Product Support Bulletin 2009-027

Maintenance of Way ~ Work Equipment Bulletin

SUBJECT: Efactor Pressure Switch Kit - 98760062

MACHINE MODEL(S): TRIPP – Tie Exchanger

Figure 1
Allen-Bradley Propel Pressure Switches - 78893008

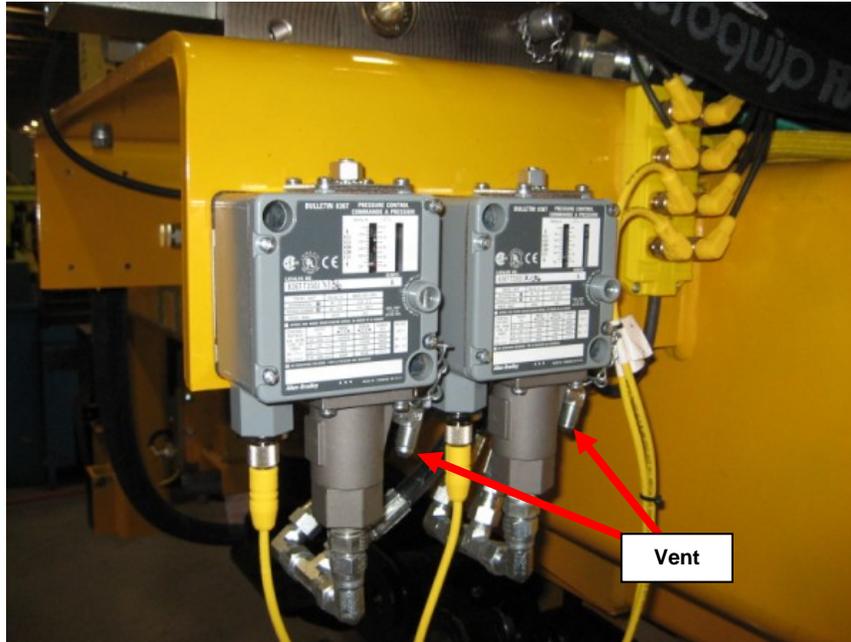
SUMMARY: The TRIPP uses two Pressure Switches to provide a forward or reverse travel input signal into the machine's PLC control. The original 78893008 Allen-Bradley Pressure Switch used in these applications has a tendency to leak oil from the switch vent. See Figure 1 on Page 2.

The original Pressure Switches have been replaced by a 78893010 Efactor Pressure Switch. See Figure 2 on Page 2. This switch has been an option for some customers but will now be standard on all new machines starting with s/n 760355. Kit 98760062 is available to convert from Allen-Bradley to Efactor pressure switches.

ACTION: The original Allen-Bradley switches are easily replaced using the 98760062 Efactor Pressure Switch Kit. This kit contains 2 of the 78893010 Pressure Switches, 21000049 mounting bracket, hardware and instructions. Installation consists of welding the mounting bracket to the machine, mounting the switches and connecting the hose and electrical cables. The existing hoses and cables are reused. Installation should take about 30 minutes.
